~~TRANS/WP.29/GRSP/2005/6~~
~~9 March 2005~~

PROPOSAL FOR DRAFT AMENDMENTS TO REGULATION No. 44
(Child restraints)

Transmitted by the expert from France on behalf of the ad hoc group

**CURVE OF TROLLEY' S, DECELERATION OR ACCELERATION,
AS FUNCTION OF TIME
(Curve for testing stopping devices)
FRONTAL IMPACT**

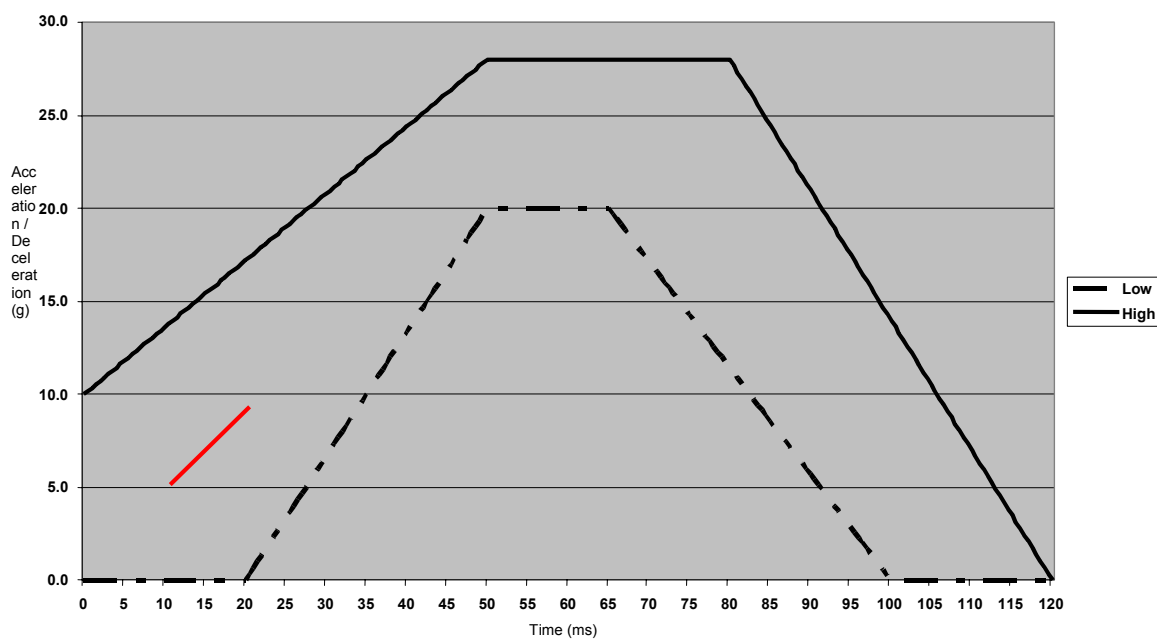
Annex 7, amend to read:

CURVE OF TROLLEY' S, DECELERATION **OR ACCELERATION,**
AS FUNCTION OF TIME
(Curve for testing stopping devices)

The additional segment (see paragraph 8.1.3.1.3.2.) applies only for acceleration sled

Test Speed: 50 (+0 ; - 2) km/h
Stopping distance: 650 ± 30mm

Time (ms)	Acceleration (g) Low corridor	Acceleration (g) High corridor
0	-	10
20	0	-
50	20	28
65	20	-
80	-	28
100	0	-
120	-	0

**CURVES OF TROLLEY' S, DECELERATION OR ACCELERATION,
AS FUNCTION OF TIME
(Curve for testing stopping devices)
REAR IMPACT**

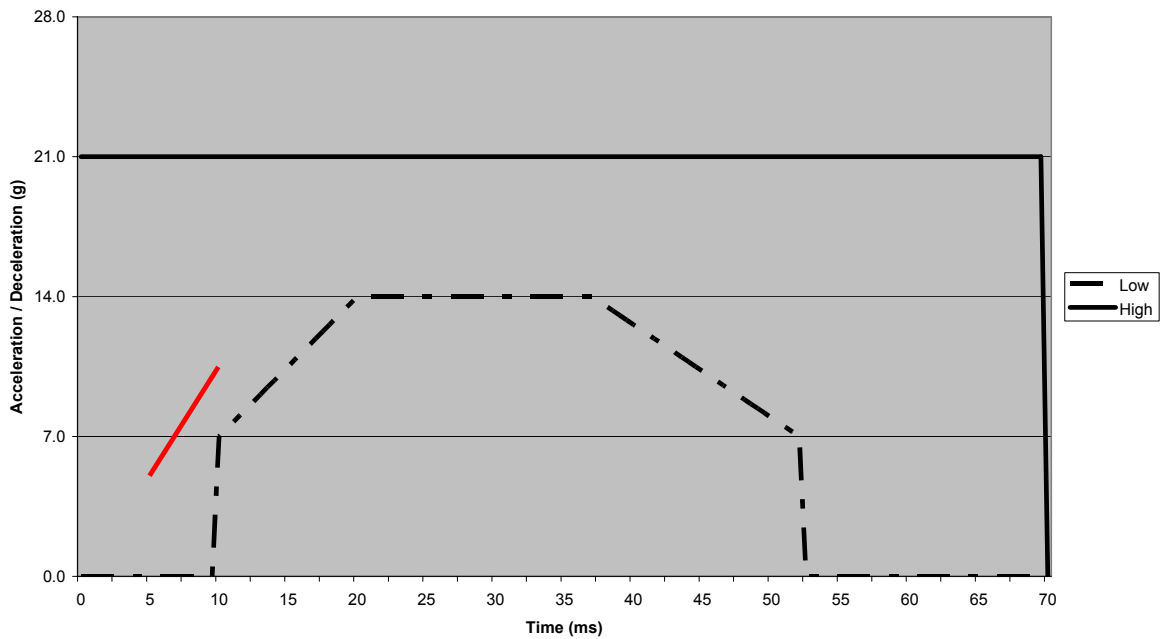
The additional segment (see paragraph 8.1.3.1.3.2.) applies only for acceleration sled.

Test Speed: 30 (+2 ; - 0) km/h
Stopping distance: 275 ± 20mm

Time (ms)	Acceleration (g) Low corridor	Acceleration (g) High corridor
0	-	21
10	0	
10	7	-
20	14	-
37	14	-
52	7	-
52	0	
70	-	21
70	-	0
